License No. 04-29022-01
Docket No. 030-31988

> With regards to License No. 04-29022-01, Docket No. 030-31988, I
> reviewed the NOAA docket file as part of my decommissioning review. I
> have two questions that I was hoping you could answer.

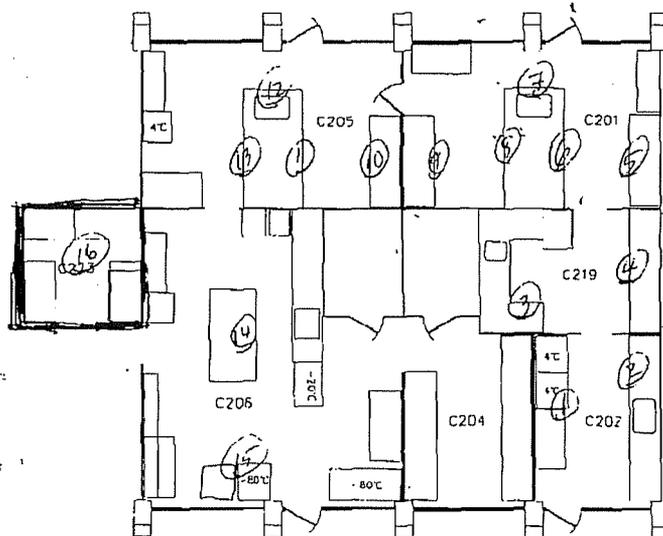
> 2. NOAA applications dated prior to 1995 mention several rooms that may
> or may not have been used: C-219, C-201, C-205, and portions of C-206.
> Please confirm whether these rooms were actually used, and if the rooms
> were subsequently decommissioned.

The lab is being decommissioned as of this date for use with radionuclides. The boxed in area on the floor plan will be the only remaining licensed area.

Concerning rooms C-201, C-205, C-206 and C-219, I have attached a .PDF file, named "SWFSC Wipe test 1996", which has the room maps and wipe test data documenting that all of the areas were tested and were clean

at the time of the room consolidation. Please use this data to confirm that these room were decommissioned and consolidated into room C-223.
